# SERVICE BULLETIN

**TITLE:** Indicating - Replacement of the pressure switch

Model:	AS350
Version:	B3
Helicopters PRE MOD:	0720202
Helicopters POST MOD:	0770000 or 0770004

[SB AS350-29-31-0001](#)

**HYDRAULIC SINGLE GENERATION**

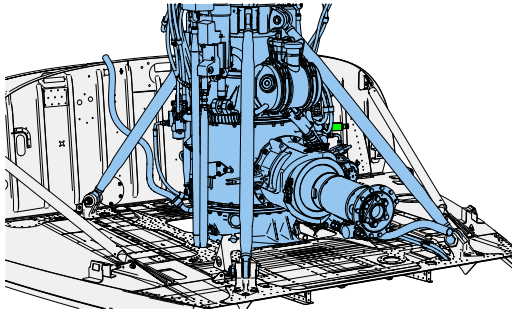
- 11.1.2. Replacement of the pressure switch:
- Remove the pressure switch, refer to [AMM 29-10-00.4-3](#)
  - Install the PRESSURE SWITCH 704A37721002 (3) and the O RING DHS621-100.03 (2), refer to [AMM 29-10-00.4-3](#).

**HYDRAULIC DUAL GENERATION**

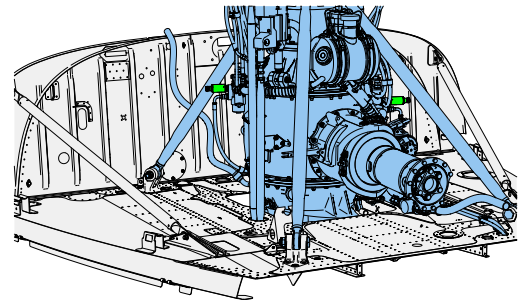
- 11.1.1. Replacement of the pressure switches:
- Remove the pressure switches, refer to [AMM 29-11-00.4-1](#)
  - Install the two PRESSURE SWITCH 704A37721001 (1) and the two O RING DHS621-100.03 (2), refer to [AMM 29-11-00.4-1](#).
